Move BFT Connector or Lose it!

HERE'S YOUR
CHANCE TO FIX
ONE OF THOSE
PROBLEMS ON
THE M1A2 SEP.

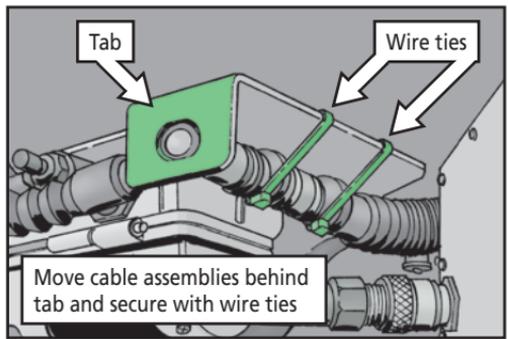
The 1W102-7 P8 connector for the Blue Force Tracker (BFT) system is mounted to the turret roof next to the gunner's dome light. That puts it right smack in the way of the recoil path of the main gun when it's fired at maximum depression.

The 1W102-7 P8 connector bracket is being redesigned to eliminate this interference. But until that happens, you'll need to move the connector out of harm's way. Here's how:

1. Disconnect the 1W102-7 P8 connector from the 1W352-7 J1 harness connector.
2. Remove the harness connector from its current position on the bracket tab.
3. Connect the 1W102-7 P8 and 1W352-7 J1 connectors back together.
4. Move the reconnected cable assemblies **behind** the mounting bracket's tab.
5. Secure the cable assemblies to the mounting bracket using two cable ties.
